Transportation Impact Study Addendum

PROPOSED RESIDENTIAL DEVELOPMENT

Harvest Moon Drive and Emil Kolb Parkway
Town of Caledon

**Re: Engineering Service – Transportation Impact Study Addendum
Proposed Residential Development
Harvest Moon Drive and Emil Kolb Parkway, Town of Caledon
Our Project No. NT-20-113**

DRAWING TITLE:
PAVEMENT MARKING & SIGNAGE PLAN

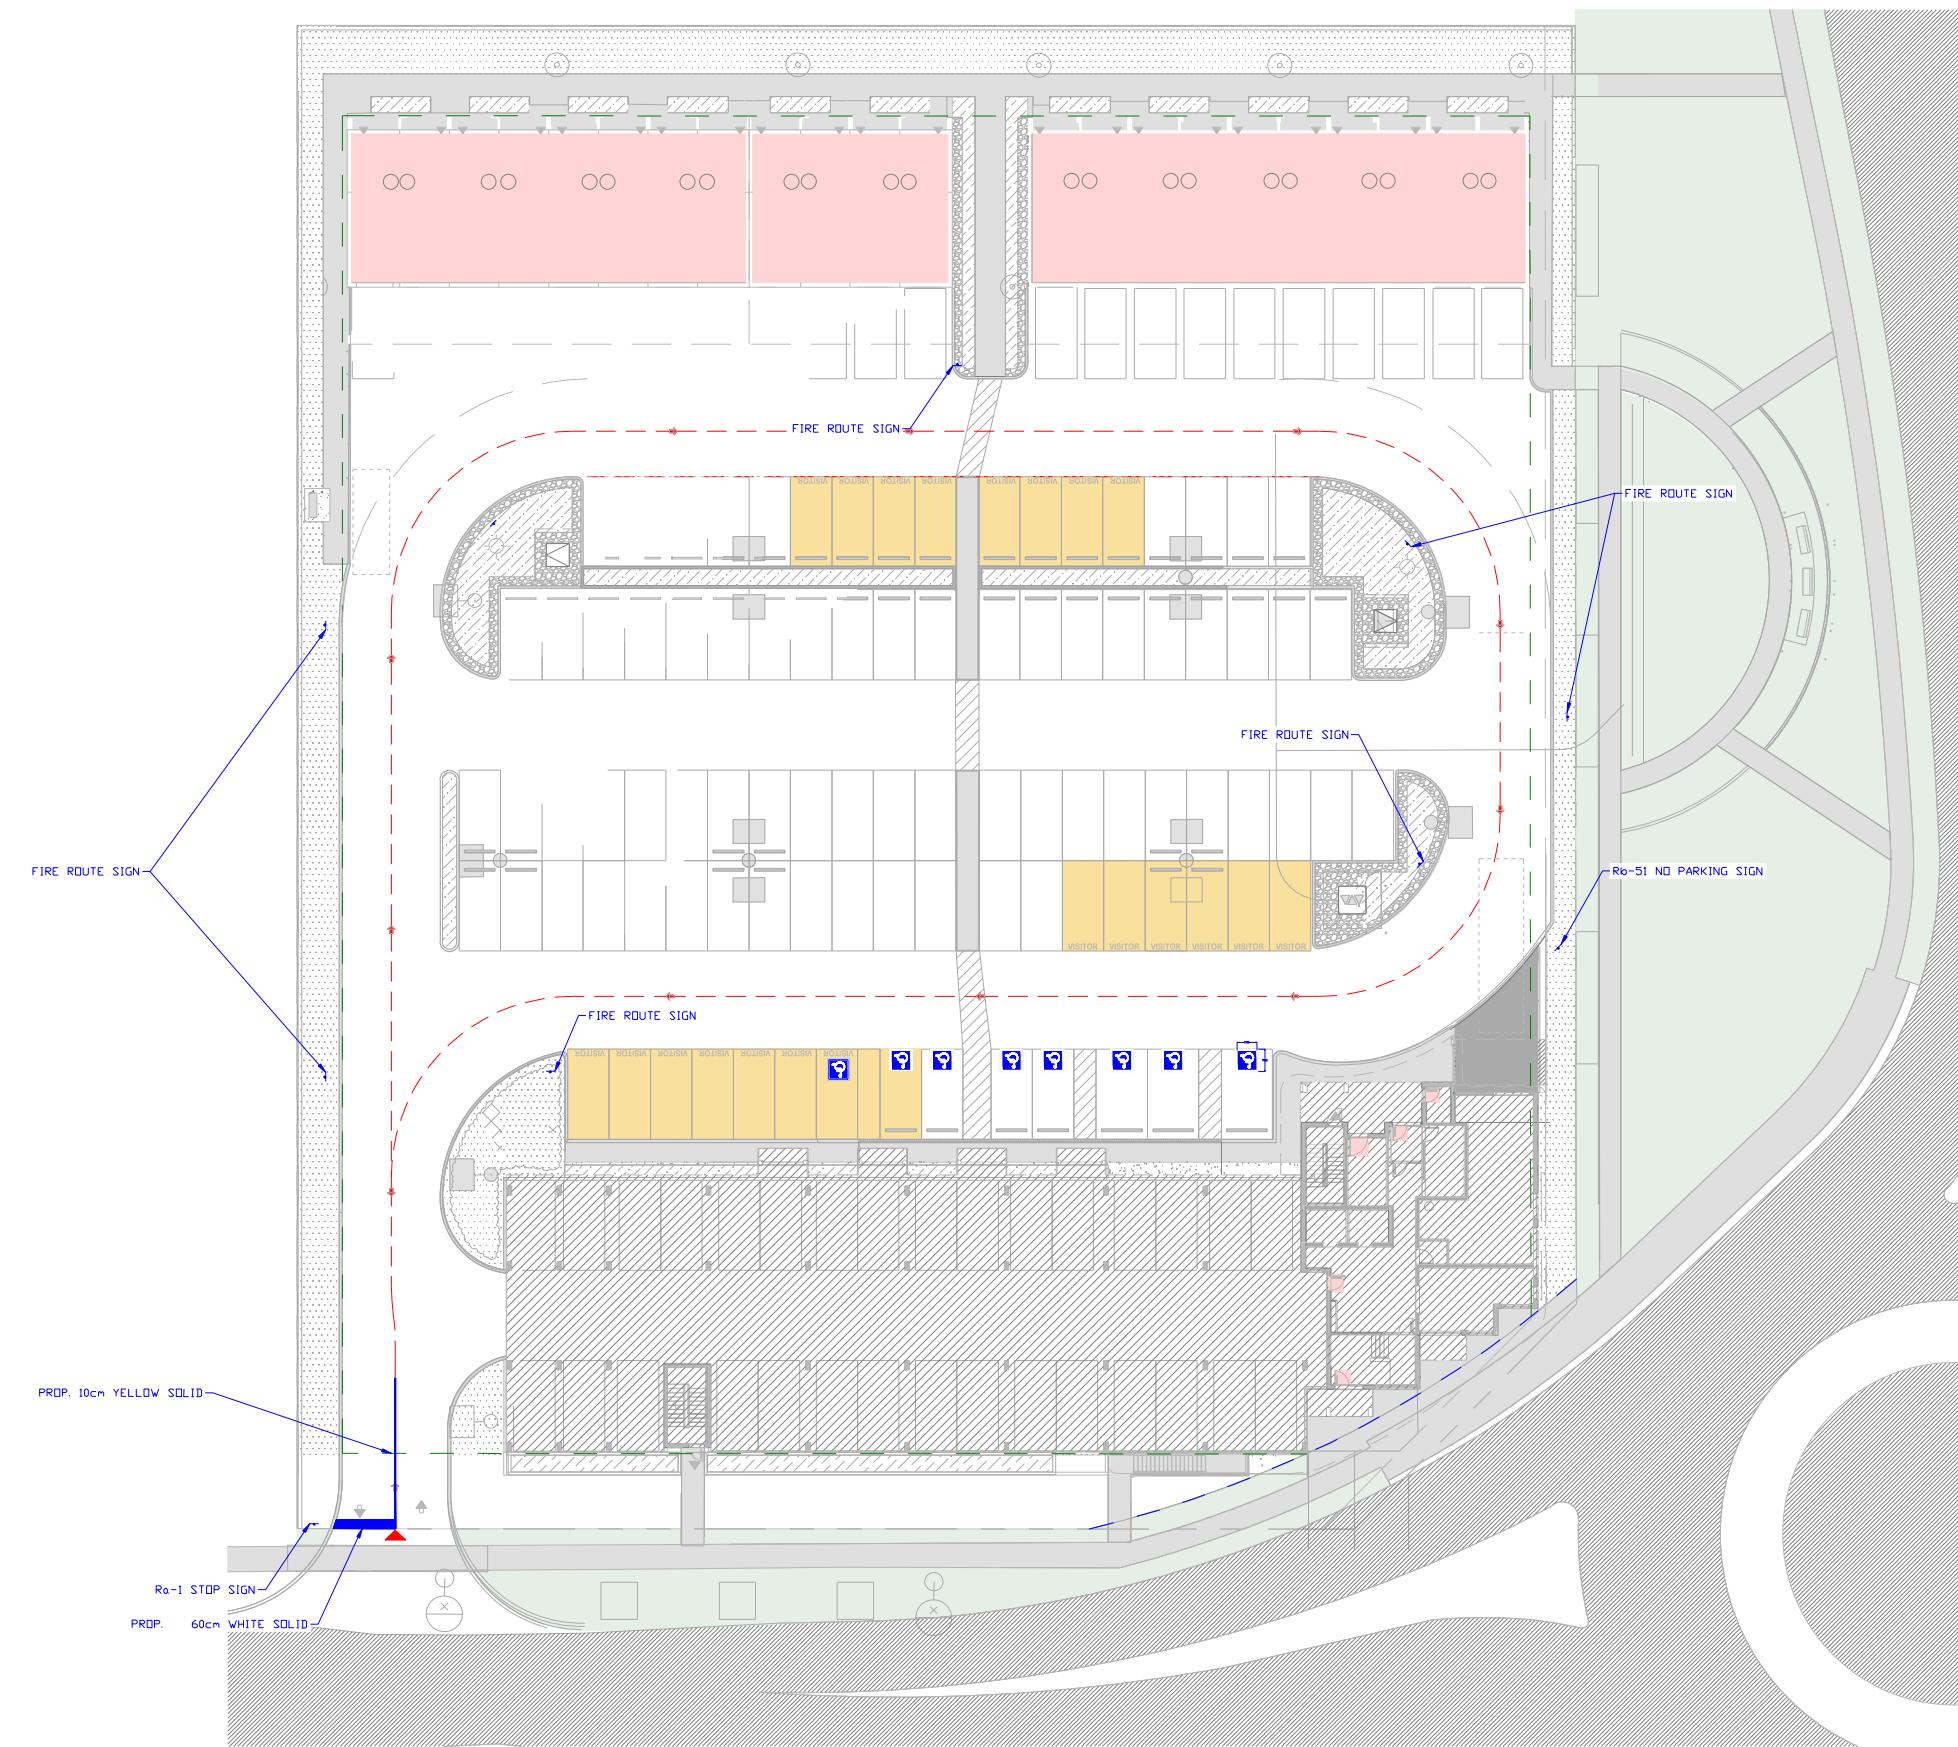
9. A detailed Pavement Markings and Signage Plan is required and must include the following:

- All traffic signage to comply with the Ontario Traffic Manual and be installed on streetlight poles where possible.
- The plan must clearly show:
 - Roadways
 - Property lines
 - Driveways
 - Fire hydrants
 - Sidewalks
 - Street lighting
 - Traffic signage (regulatory, warning, information)
 - Street trees
 - Tactile surfaces
 - Pavement markings
- All signage must align with:
 - The Town's Traffic By-Law
 - Accessibility for Ontarians with Disabilities Act (AODA)
 - Highway Traffic Act (HTA)
- Refer to the Town's Traffic By-law Schedule P for fire route signage and HTA for accessible parking signage requirements.
- Please include a note on the Site Plan stating that all pavement markings and signage must be installed in accordance with the approved Pavement Markings and Signage Plan to assist Town staff during site inspections.

NEXTRANS RESPONSE: Acknowledged. The Pavement Marking and Signage Plan is enclosed in **Appendix E**.
